RE: Revised Remedial Design
4191 First Street, Pleasanton, California
Fuel Leak Case No.: RO0000361

Revised Remedial Design

Unocal Site 7376
4191 First Street
Pleasanton California
Alameda County Fuel Leak Case No. RO0000361

**Revised Remedial Design
Response to ACEH Comments**

Figure 1	Site Plan with SVE Well Layout
Attachment 1	Graphical ROI Determination

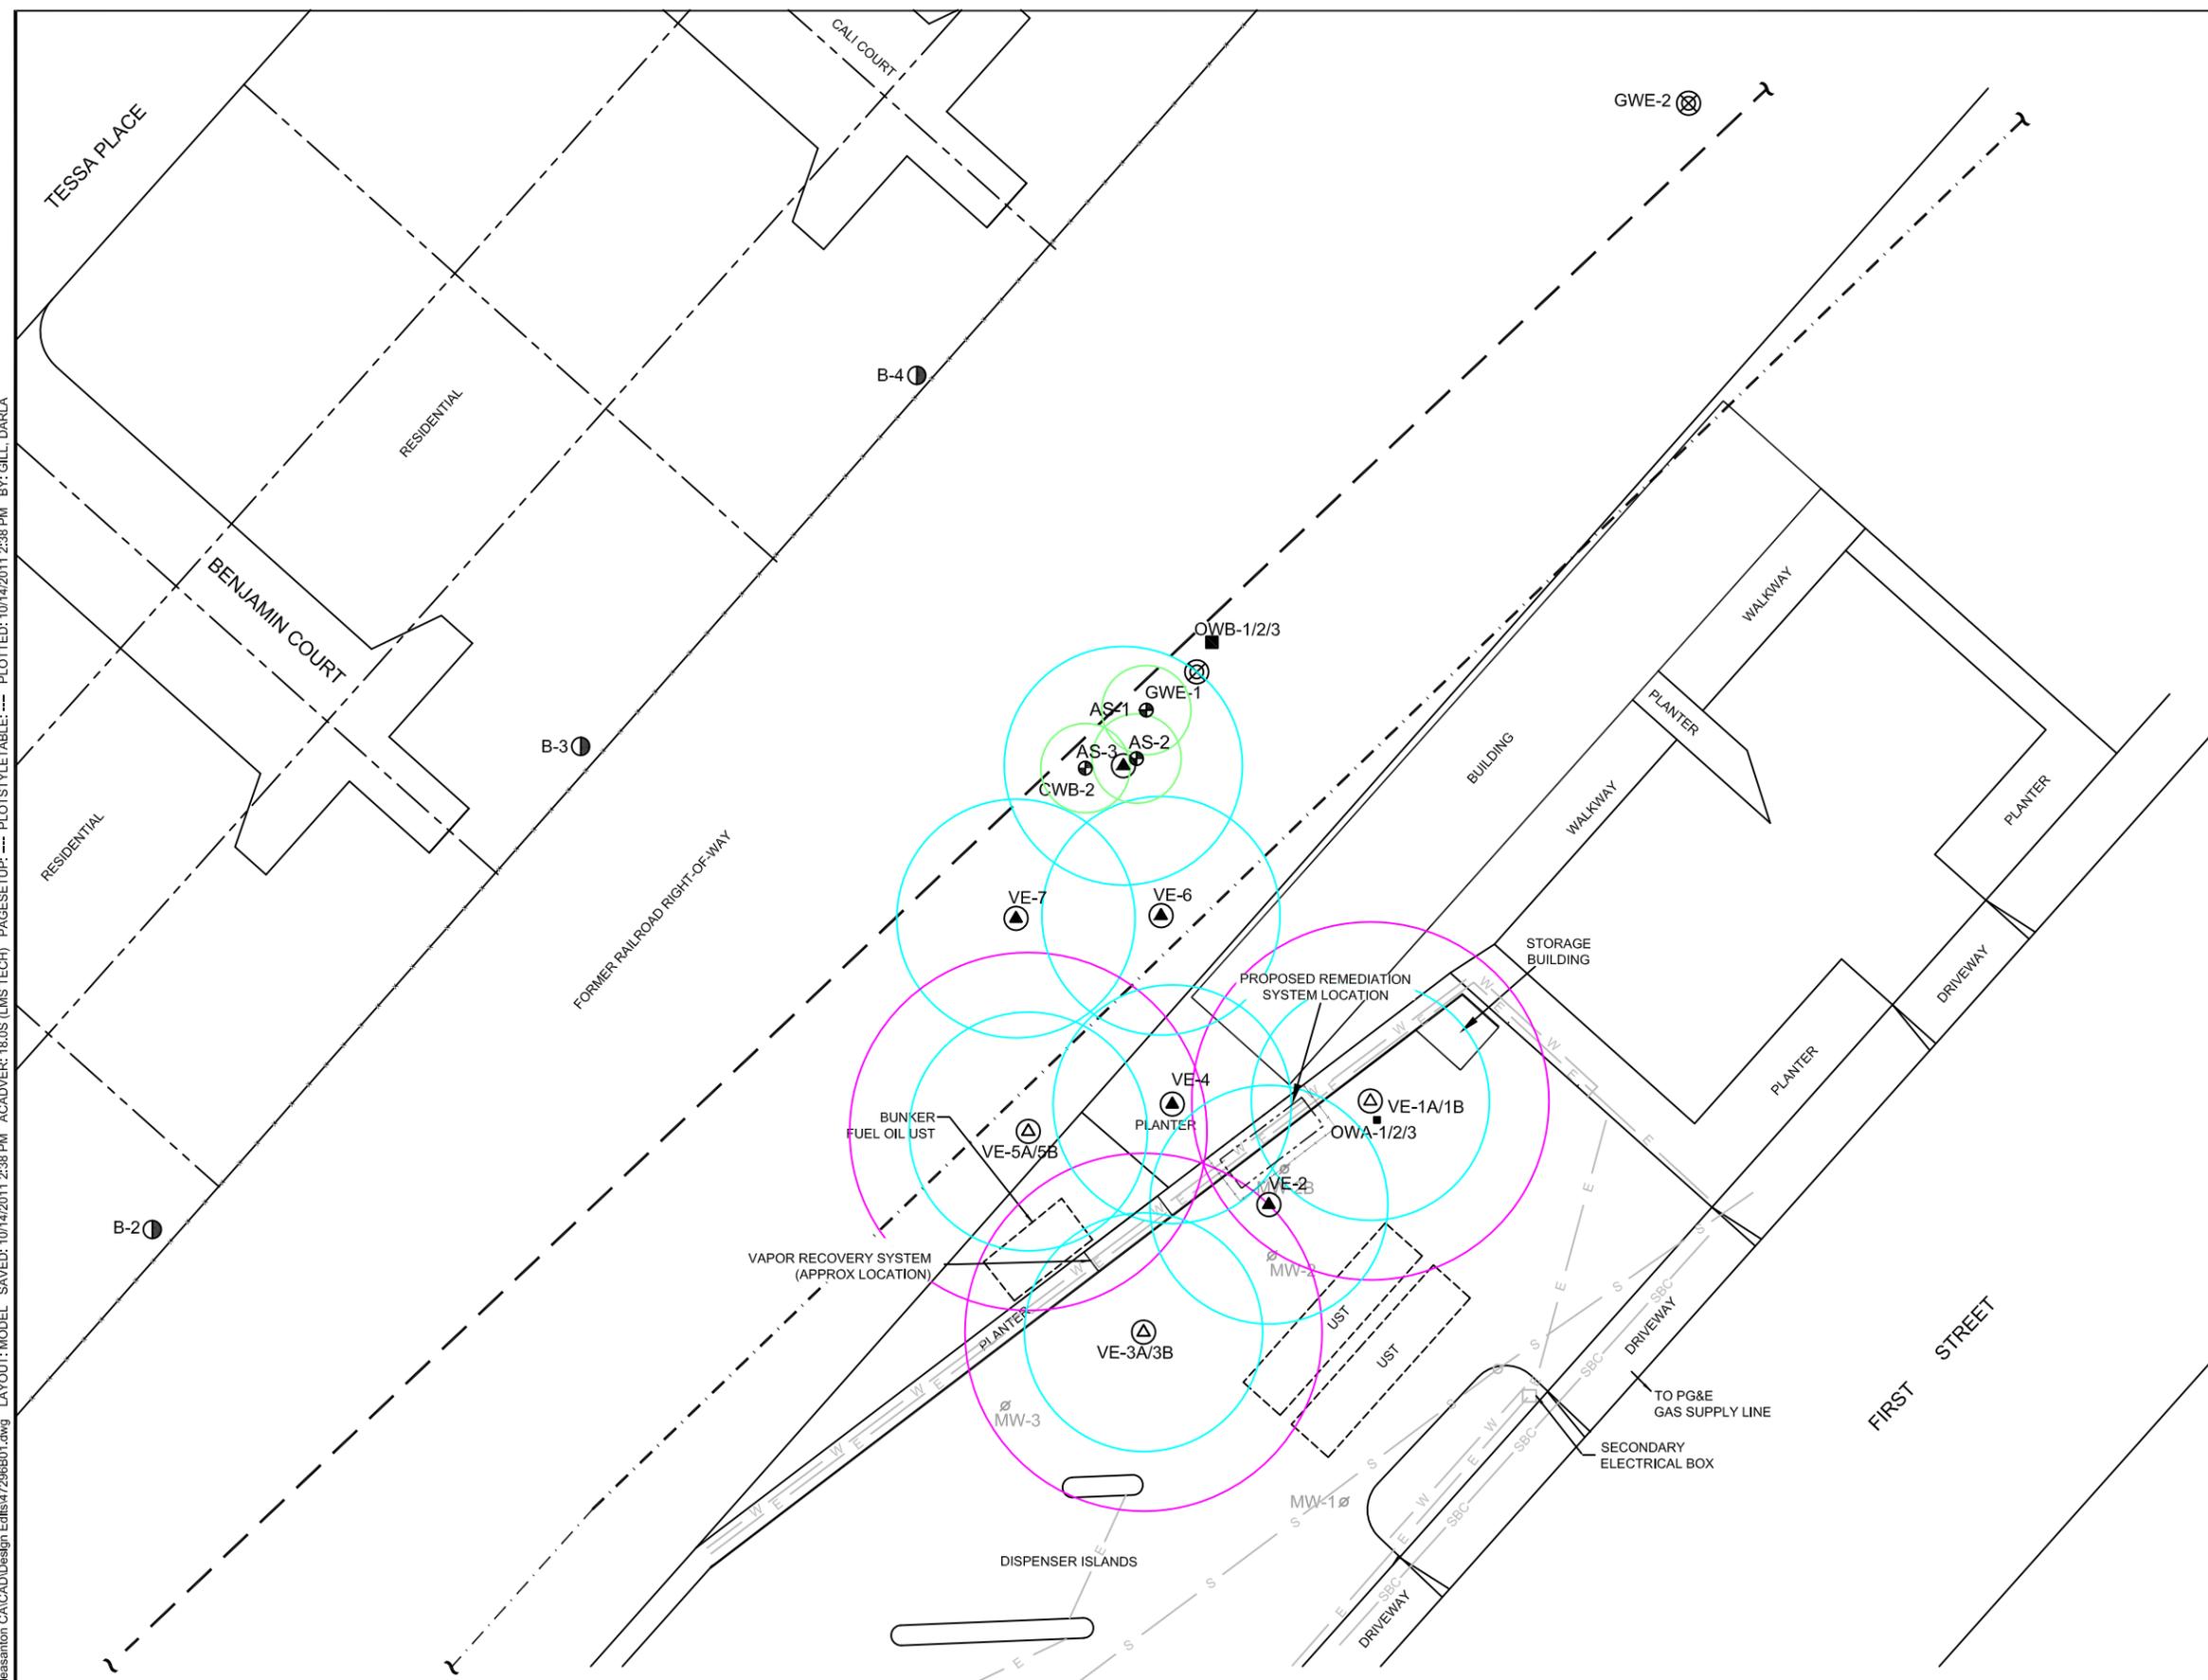
- Miscalculation of the soil vapor extraction (SVE) radius of influence (ROI) and subsequent challenges with the SVE vapor well layout
- Concerns regarding the purpose of the groundwater extraction and treatment (GWET) system and the incorporation of air sparge (AS)
- Electrical and natural gas limitations
- Access limitations and phased approach for implementation
- GWET as a contingency

Graphical representation of ROI is typically presented on a log normal basis. The ROI as presented in the Revised RAP had both the vacuum and distance in a normal scale which resulted in a ROI of 12 feet. As a result the ROI presented with the Revised RAP underestimates the influence of both the shallow and deep SVE wells.

Utilizing the revised ROI, the SVE well field layout was amended resulting in a reduction of SVE wells from 29 to 11 (3 shallow SVE wells and 8 deep wells). The revised well field layout including projected ROI is presented as Figure 1.

Lithology at this site appears conducive to AS. AS has a higher probability of success at addressing dissolved phase impacts in proximity to MW-5. Therefore, ARCADIS is proposing the incorporation of three AS wells into the system. Conservatively, a 10 foot ROI for AS was assumed. The screen interval is proposed to be 80 to 82 feet bgs but will be modified if fine grained sediments are encountered at a shallower depth. The AS well field layout including projected ROI is shown on Figure 1.

SITE MAP WITH PROPOSED SHALLOW WELL AND TRENCH LOCATIONS

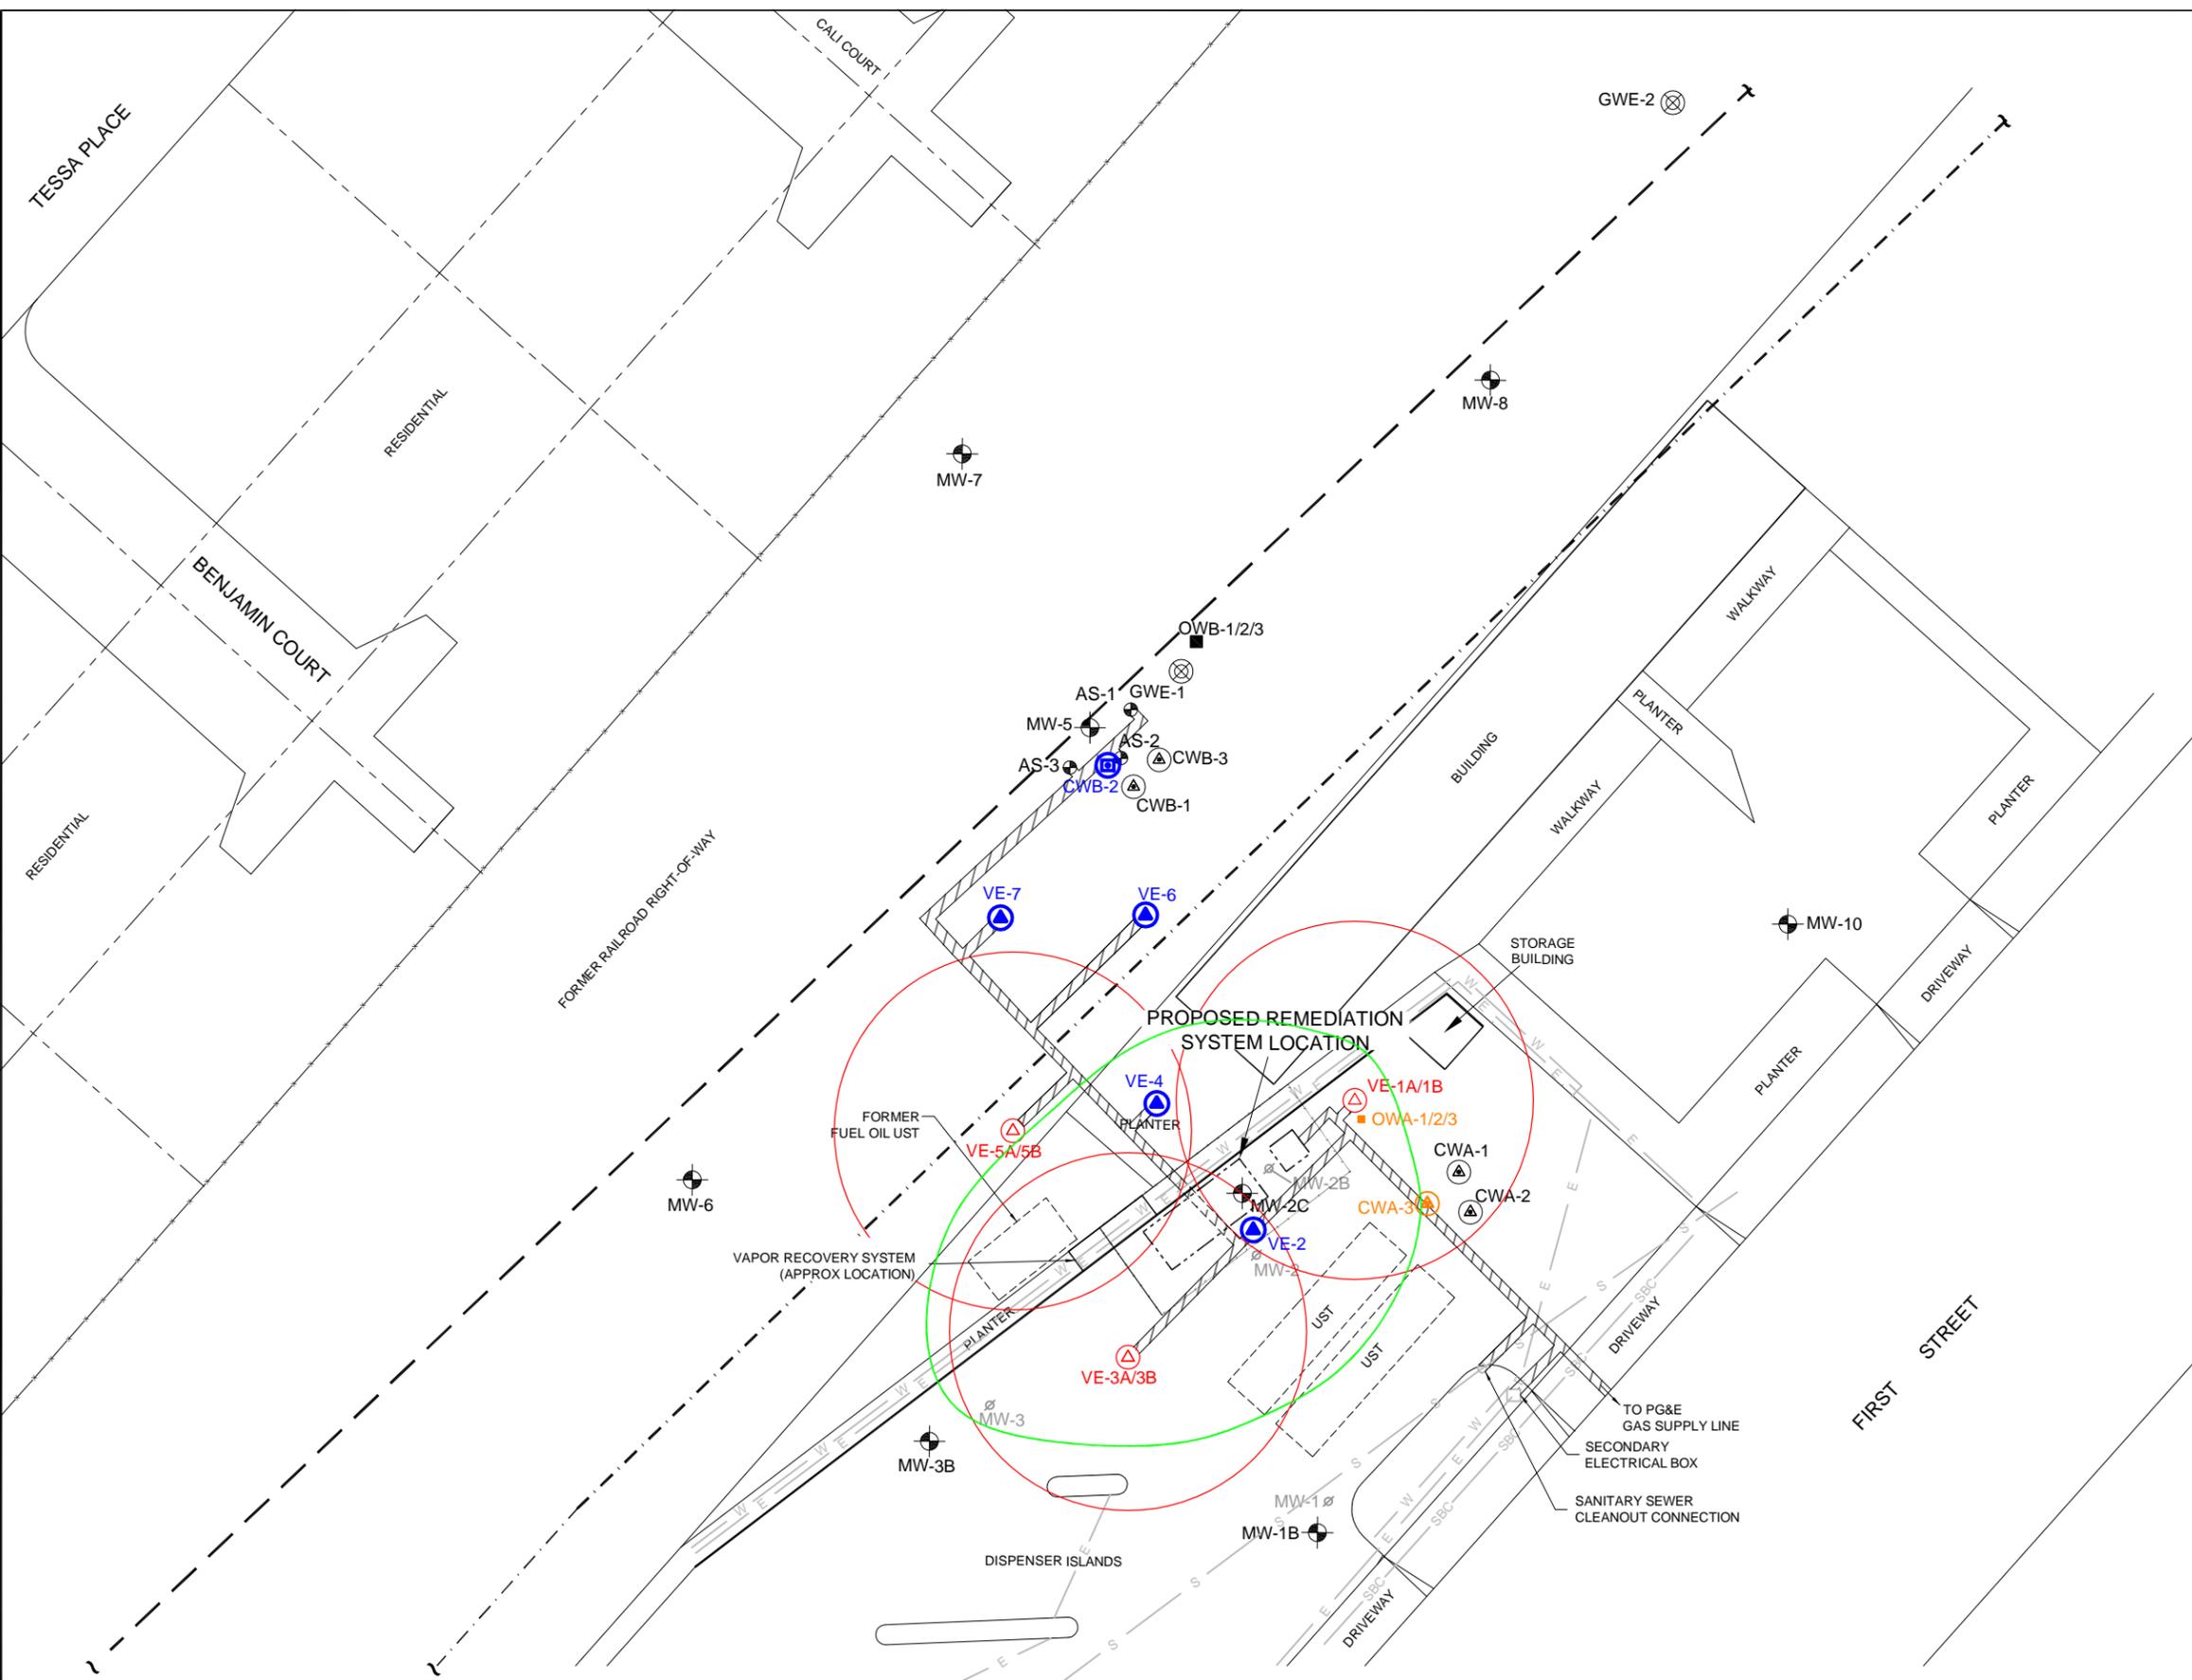
1. ***Radius of Influence and Number of SVE Wells. The Revised Remedial Design indicates that the radius of influence (ROI) was not calculated correctly and proposes the use of higher ROI values for design. As a result, the Revised Design incorporates a significantly reduced number of extraction wells for the soil vapor extraction (SVE) system. Given that the site stratigraphy appears to be complex with possible horizontal and vertical discontinuities, it is not clear that the proposed well design is conservative enough to ensure that the system will be able to adequately treat the targeted area and vertical intervals. We request that you review the site-specific conditions and re-consider the design in light of the site heterogeneity. Upon review, if you believe that the proposed design is adequate, please include a sufficient number of vapor monitoring points in the design to allow assessment of the system performance during SVE operations.***

- 2. *Air Sparging and Removal of Groundwater Extraction. The proposed incorporation of air sparging in lieu of groundwater extraction is acceptable. In the Revised Remedial Design requested below, please include the three proposed air sparging wells into the remedial system. Groundwater extraction may be used as a contingency.***

- 3. Compound Location and Abatement Equipment. In the Revised Remedial Design requested below, please include a new location for the system compound. The size of the abatement equipment may be modified as necessary to match the anticipated treatment volumes.**

After in-depth review of cross-sections developed from site boring logs, the conservative ROI presented within ARCADIS' "Revised Remedial Design" will deliver effective flow coverage despite site heterogeneity. The revised design ROI for the shallower zone (sands/gravels) and deeper zone (finer grained soil) is 30 feet and 20 feet, respectively. These conservative ROI estimates are based on the smallest ROI observed during previous pilot testing efforts to ensure adequate coverage at the site. Additionally, well construction and well layout details were designed to address interpreted lithologic heterogeneities. The majority of clay lenses or pockets causing discontinuity within the formation exist on-site. Dual-nested shallow and deep SVE wells are proposed onsite to address possible decreased influence across vertical and horizontal gradients within the formation. Screen intervals will be also open to variation in the field to compensate for any unanticipated impermeable layers observed during well installation.

Onsite monitoring wells OWA-1 and CWA-3 will be used to monitor shallow induced vacuum gradients (Figure 1A). In addition, proposed vapor extraction wells VE-1A, VE-2, and VE-3 will be used to monitor shallow induced vacuum gradients when not in operation. Onsite wells OWA-2, OWA-3, CWA-1, and CWA-2 will be used to monitor deep induced vacuum gradients.

The three proposed offsite air sparge well (AS-1, AS-2, and AS-3) locations are shown on Figures 1A and 1B. The remediation compound was designed to allow space for contingency groundwater extraction system components. A sewer cleanout connection will be made during trenching activities to allow

The new proposed remediation compound location is shown on Figures 1A and 1B. The new location selection process included evaluation of accessibility, minimal disturbance to service station operations, distance from the nearby office building, and structural stability of existing topographic conditions.
